**RECLAMATION DISTRICT NO. 1601  
TWITCHELL ISLAND  
BOARD OF TRUSTEES MEETING  
TUESDAY, AUGUST 17, 2021  
9:00 AM  
ENGINEER'S REPORT**

**I. PLAN REVIEW – USGS SEISMOGRAPH INSTALLATION**

- A. Review Draft Sites for an Encroachment Permit from USGS for the installation of seismic monitoring equipment.

Twitchell Island Levee Improvement Sacramento County, CA		 1955-2008 TWICHELL ISLAND BORING LOCATIONS STA 525+00 to 575+00 PROFILE
Reclamation District 1601 Rio Vista, CA		
Project: 073050	October 2008	Figure A-4

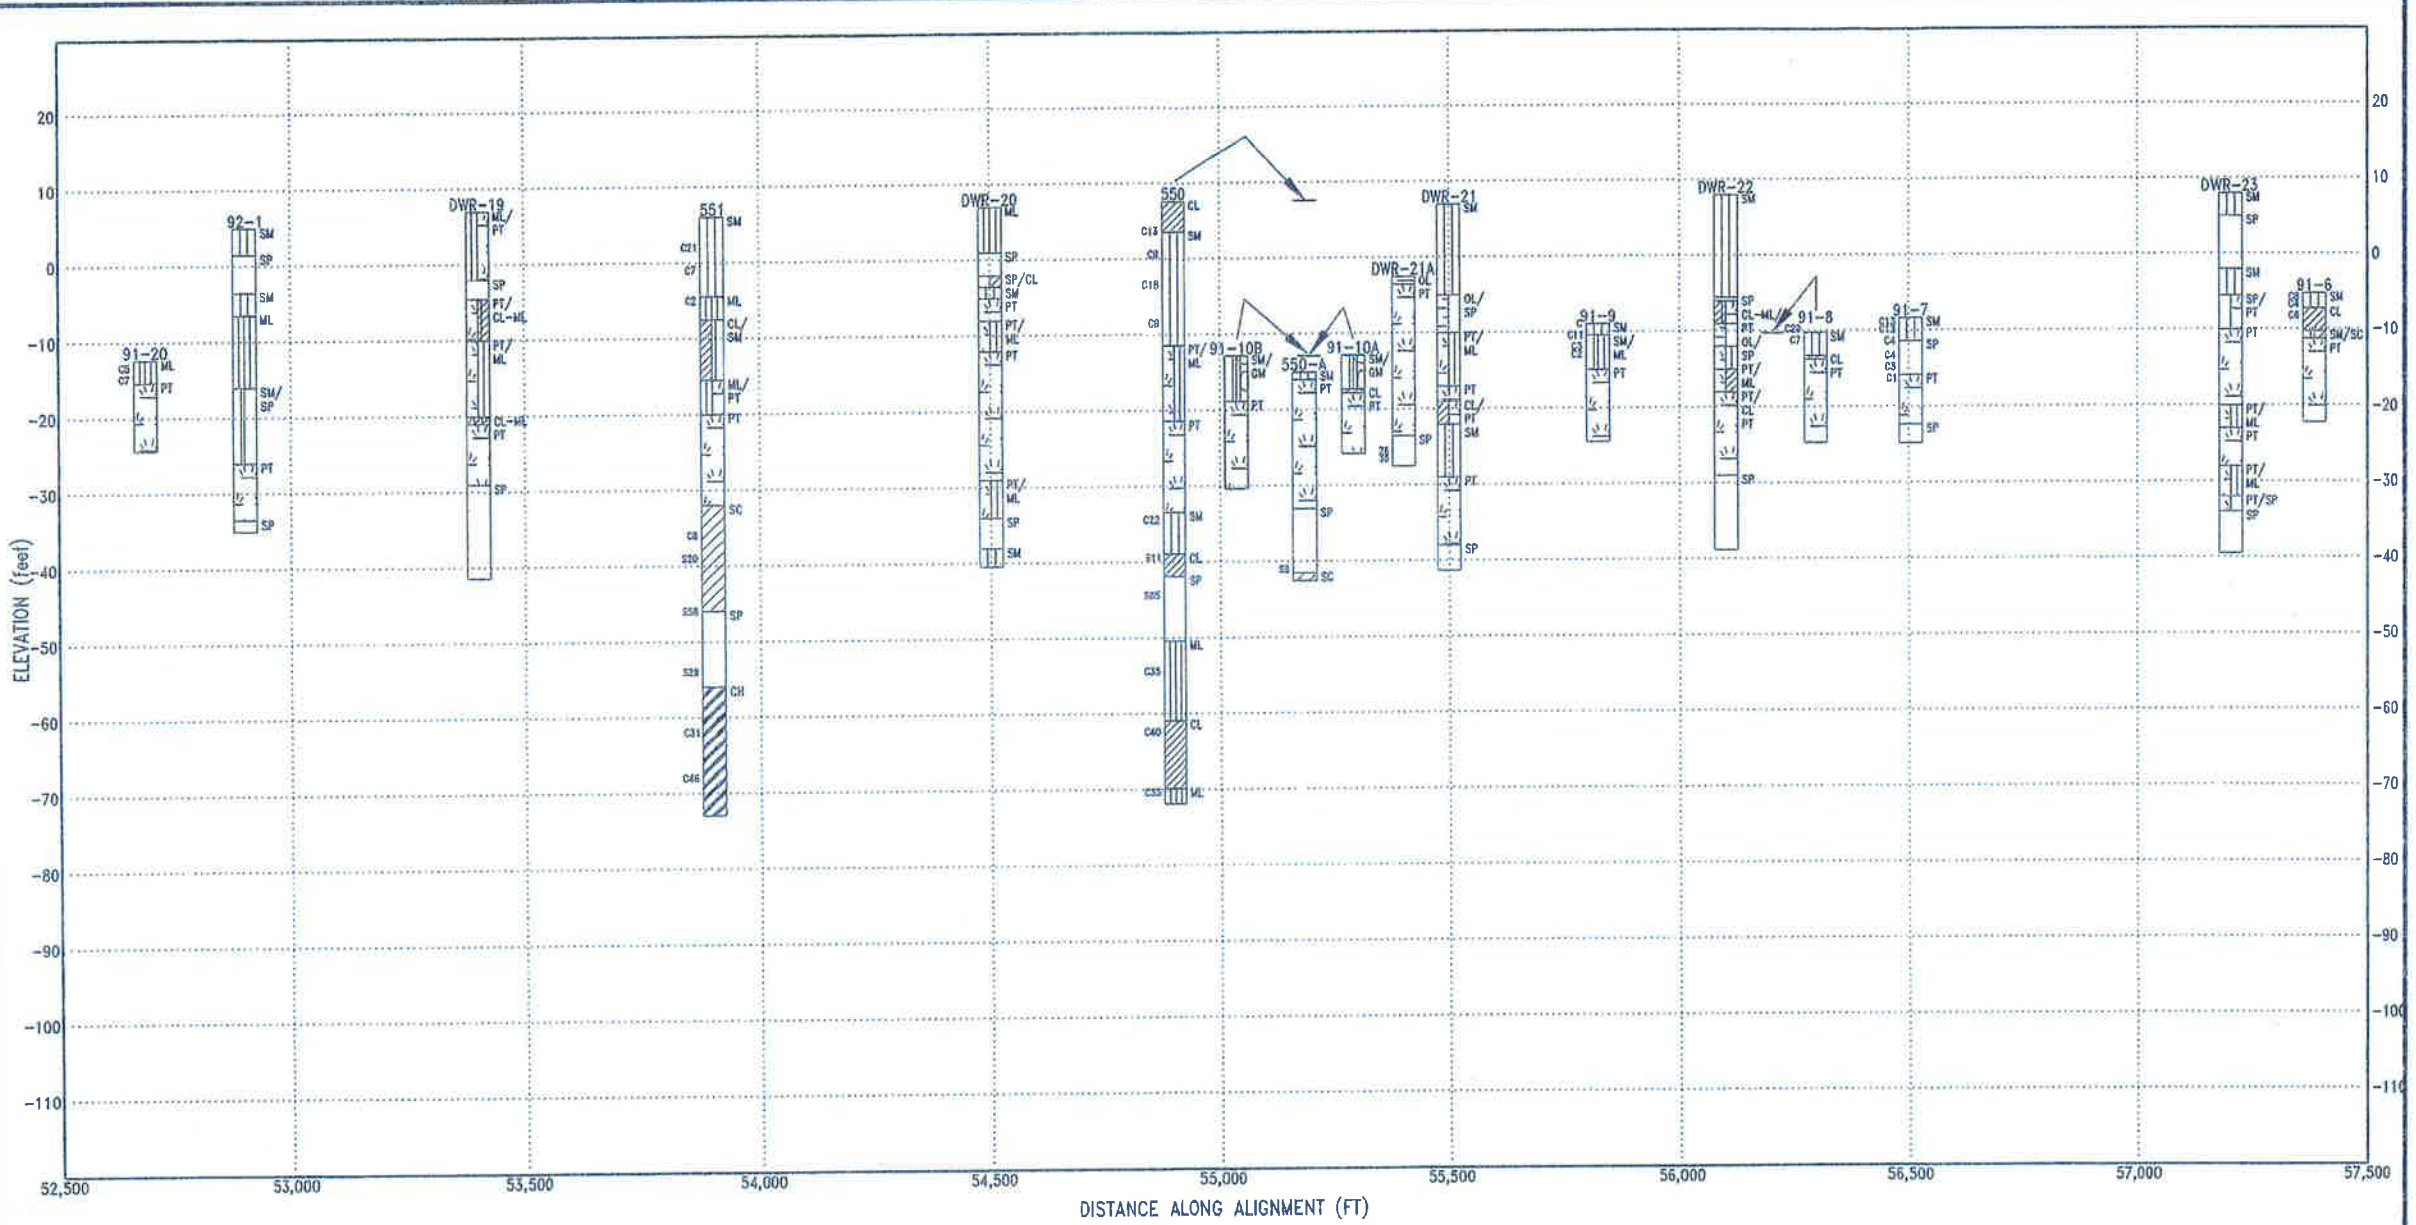
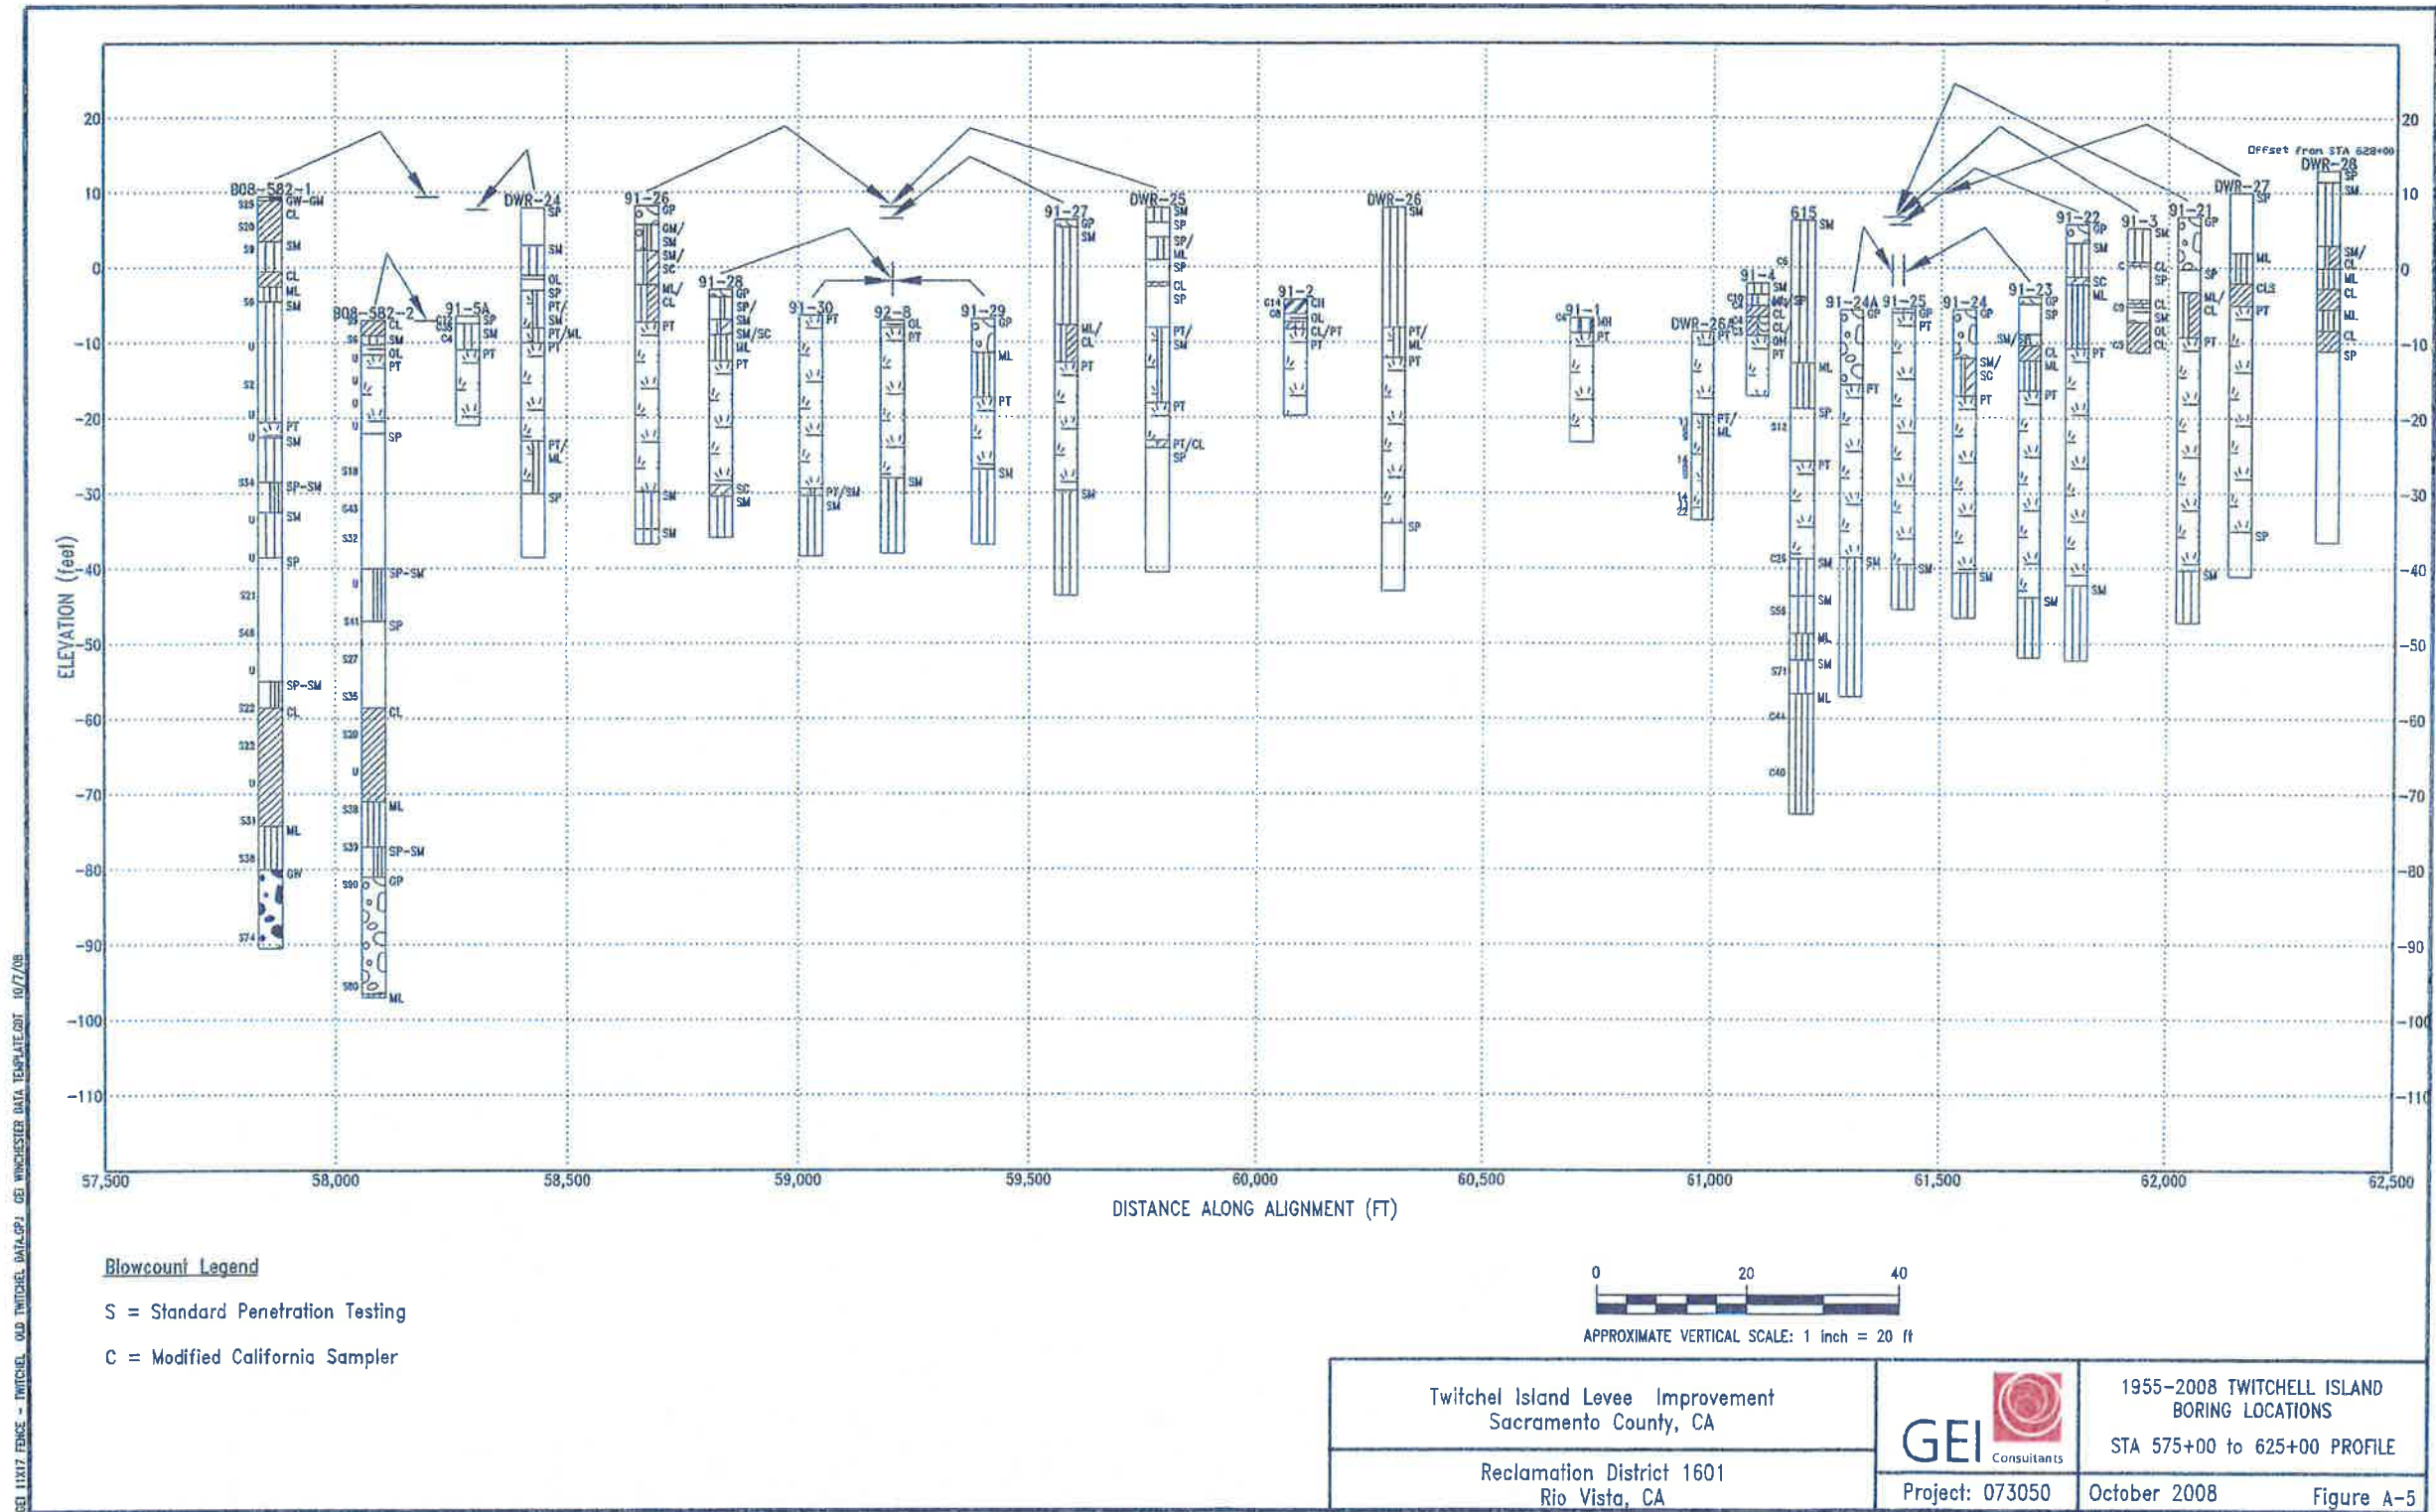
1. From the two profiles shown below (Appendix 4 pgs 12-13), do you have the following detailed boring logs that you could send to me? 91-6, 91-5A, 91-26 through 91-30 and 92-8, located between DWR-23 and DWR-25

Attached please find shape files of our levee setback line incorporating our future levee footprint, ditch, pole line and appropriate setbacks along the San Joaquin River covering the District's Future Levee Improvements. Provided you stay outside of this line you will be OK. I have included a pdf view for your quick reference at the Oulton Point site that you are considering. As for your additional questions related to the geotechnical data that we have provided you, what we currently have and any other requests for more would be an extensive search that I am unable to perform at this juncture.

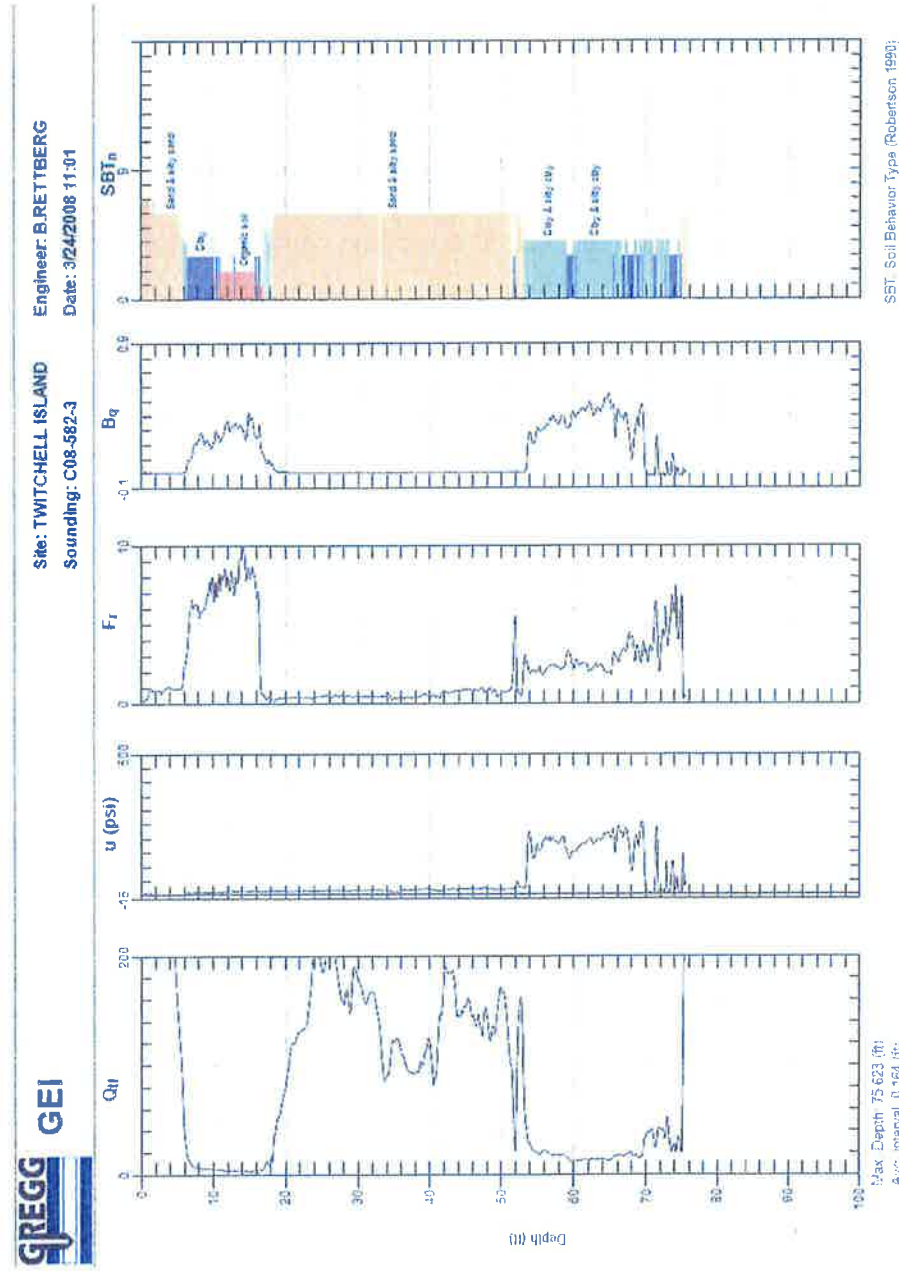
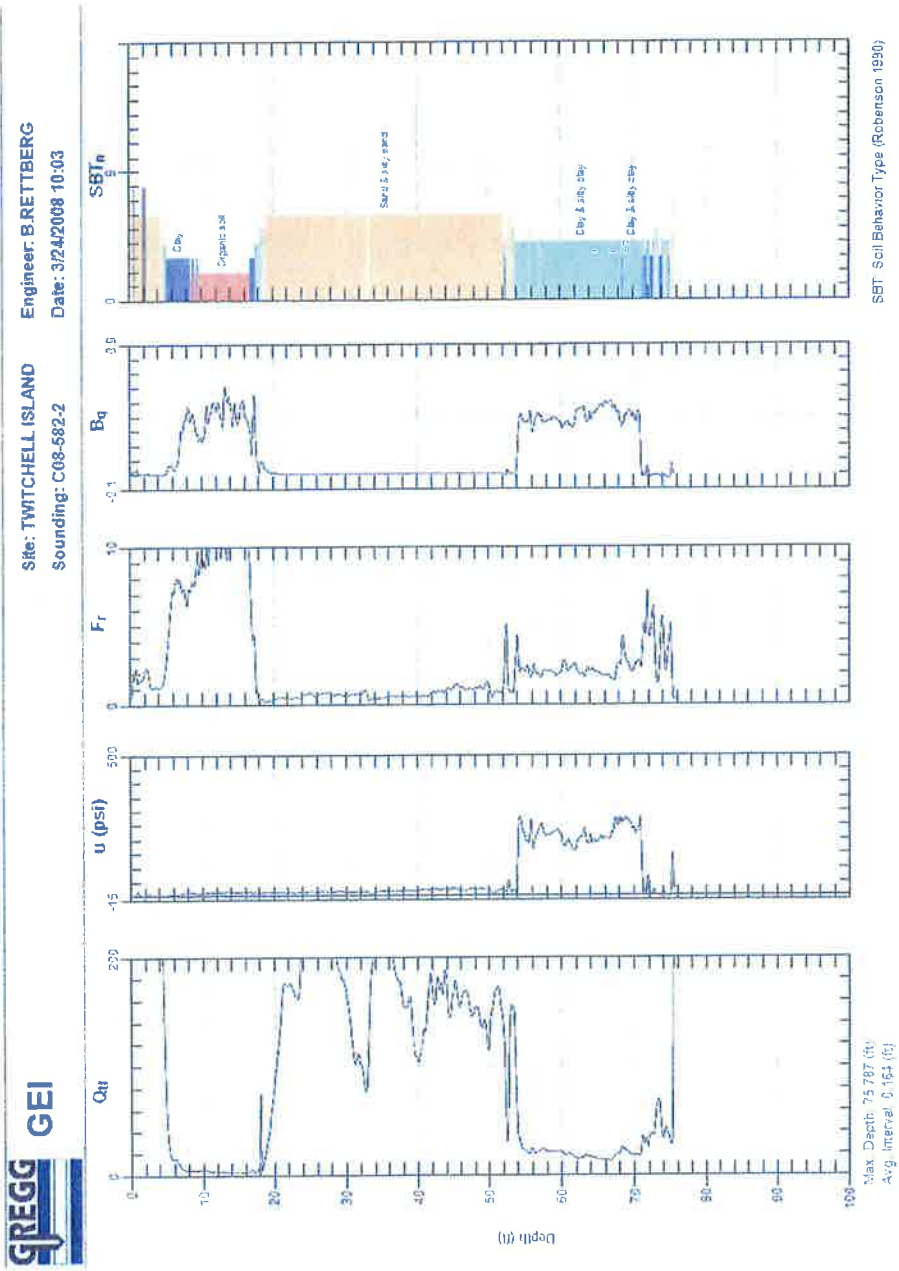
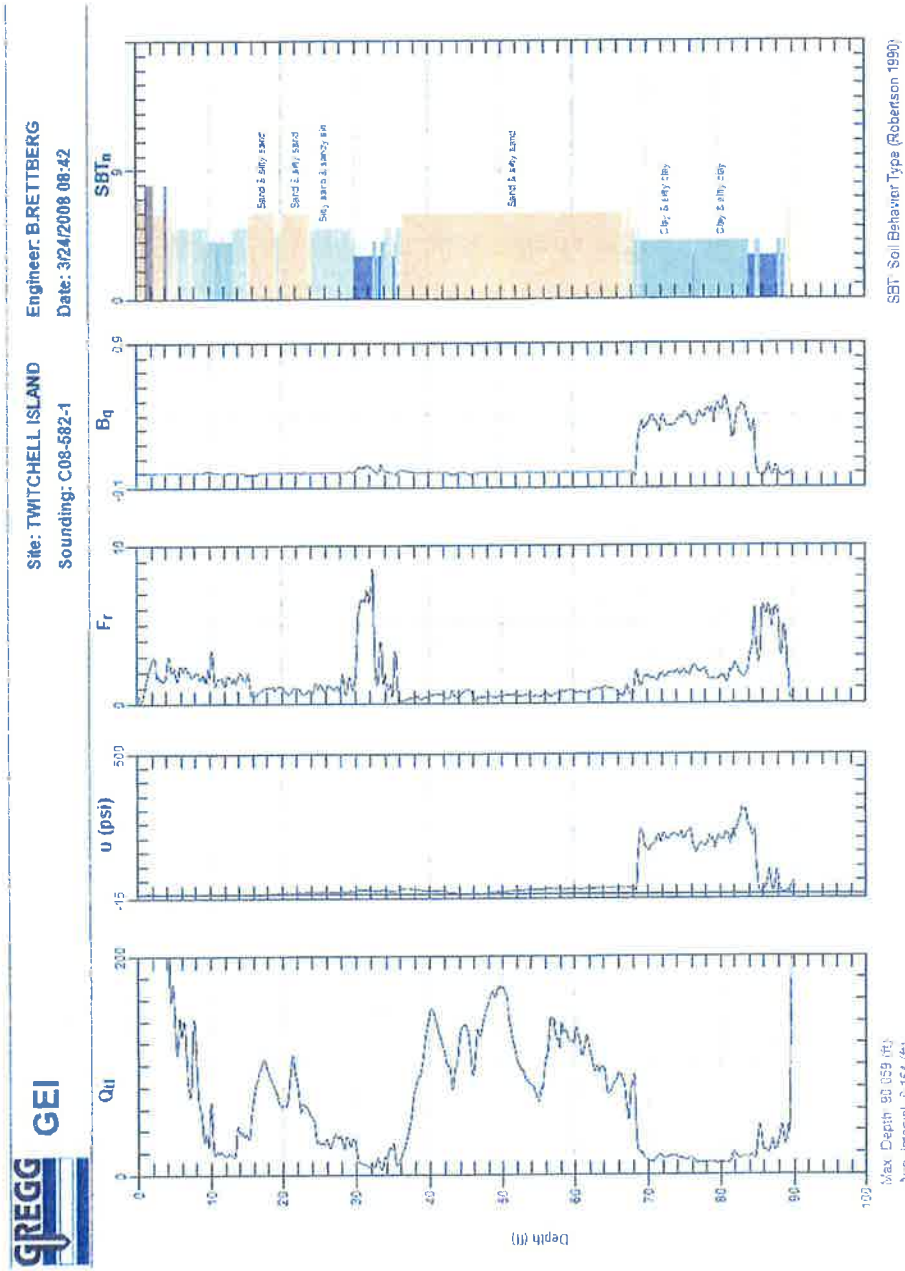
3. Do you know the specific locations of these three CPT soundings (Appendix 4 pgs 53-55) taken near marker 582+00? What is the reason for the differences between the three soundings? Levee crest vs toe?
